MALUHIA, A LONG TERM HEALTH CARE FACILITY
HAWAII HEALTH SYSTEMS CORPORATION

SUBJECT: Addendum No. 1
IFB No. 22M-0324 Maluhia – Dayroom Projects

Addendum No. 1

From: Curtis K. Miyamura
CKM Architects, LLC
Date: April 4, 2022
Re: Drawings and Specifications for Maluhia – Hospital Dayroom Projects
1027 Hala Drive
Honolulu, Oahu, Hawaii
TMK: 1-6-009:004

GRAPHIC SCALE

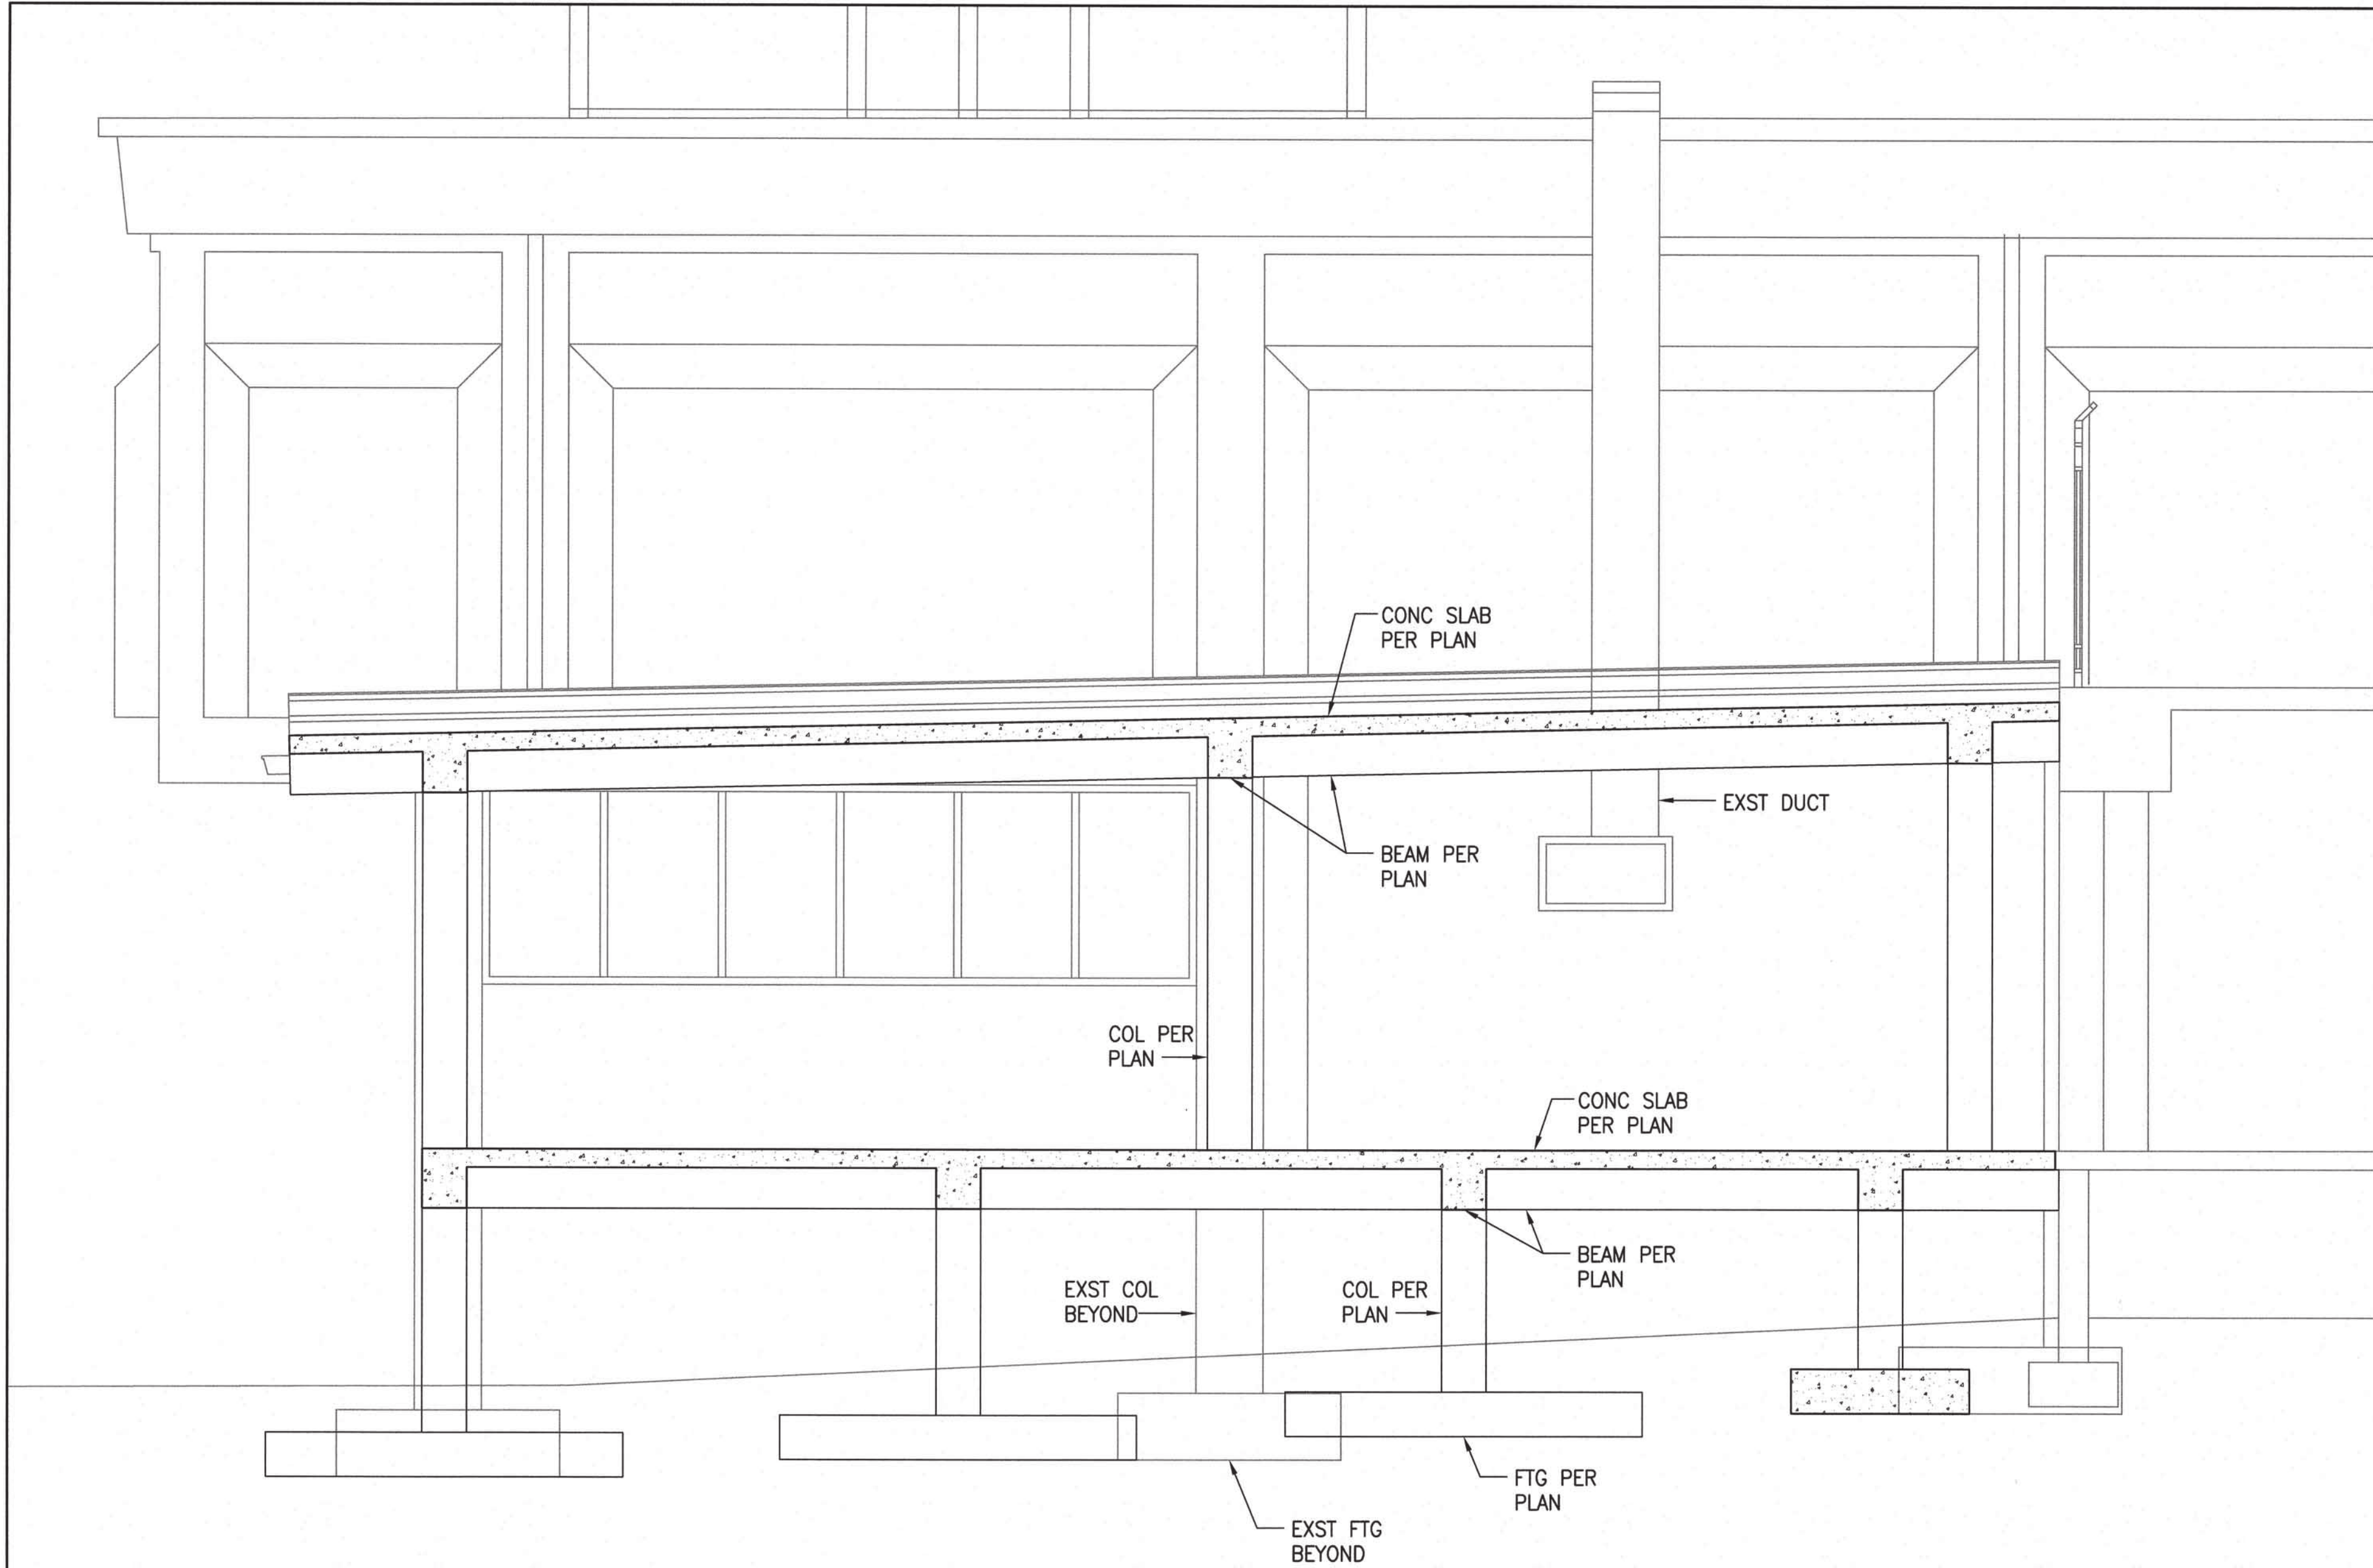
6. Reference new covered deck area: **Drawings in Addendum 1 addresses the questions for items 6a – 6e.**
 - a. Please provide details for new concrete (footing, slab, columns, beams, suspended roof deck) work (dimensions, reinforcing, etc.)

- b. Please provide subgrade preparation requirements. Noted that the footprint area beneath the new covered deck has a slope concrete ramp, an existing CMU retaining wall and an asphalt parking area.

- c. Is there a tied connection between the new concrete roof and existing concrete deck? Noted that there is an existing gutter and downspout along the face of the existing concrete deck.

- d. Along the existing building side (west side), the area below the new slab is open to structure below. Please provide details for infilling the open area if the area beneath the new slab is to be filled and tamped per A/A-4.
